M/24/19/PL

Our Ref
PLAN-027371
Date

Proposal: Replacement residential dwelling. This application may affect a Public Right of Way.
Site: 3 The Hard, Elmer PO22 6JS.
M/24/19/PL

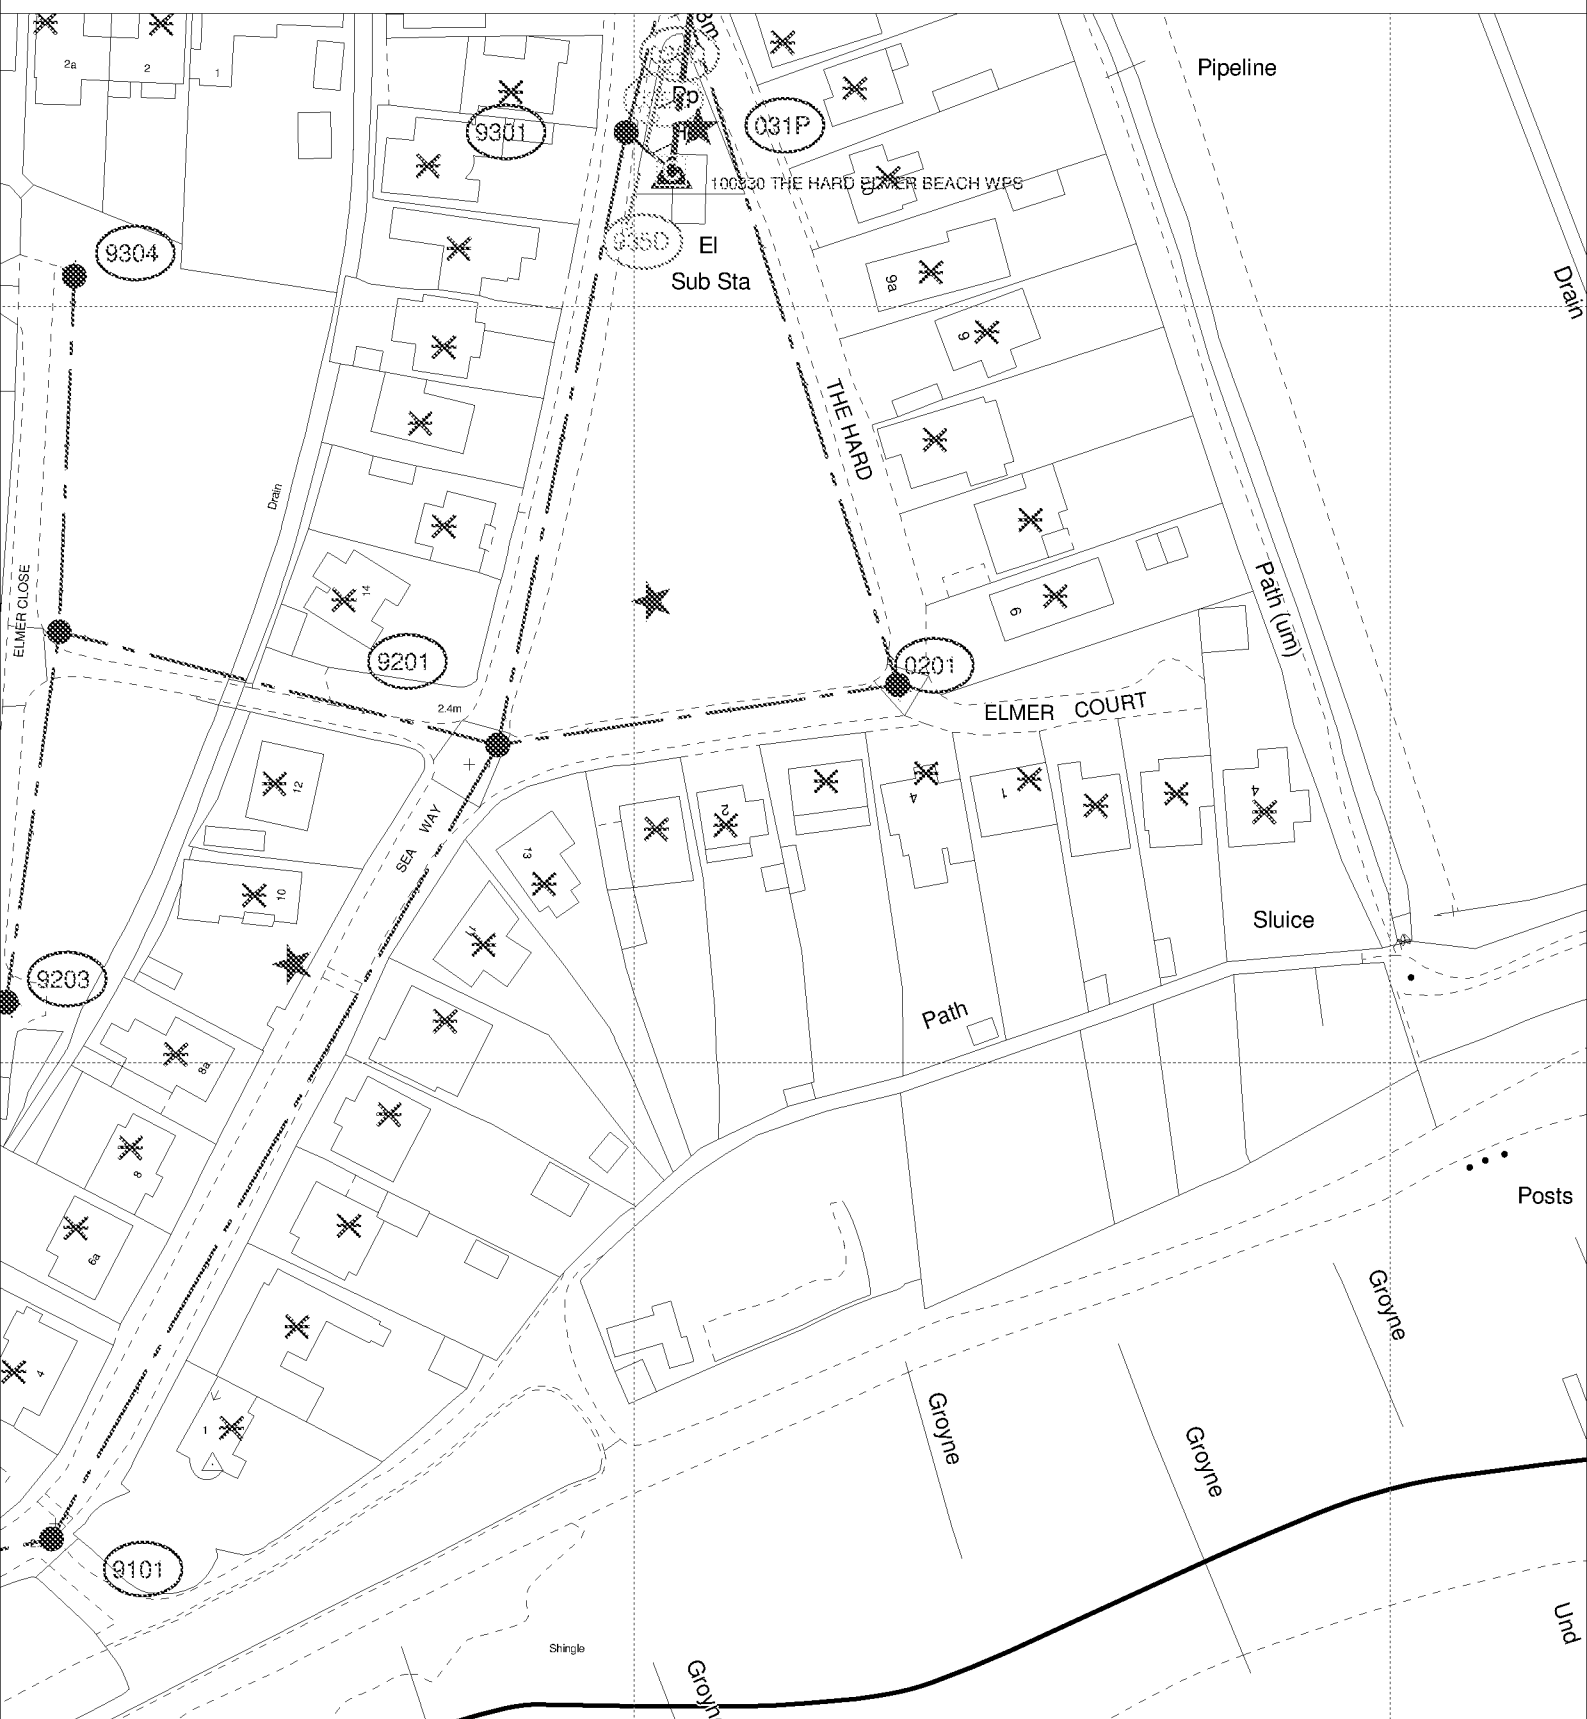
Due to surface water inundation issues in the Lidsey Catchment "The applicant is advised to adopt, where appropriate, the measures in the table "Practical measures to reduce the potential impacts of development".

Developer should look to protect the public sewerage system from inundation and infiltration, which contribute to flooding in unfavourable conditions.
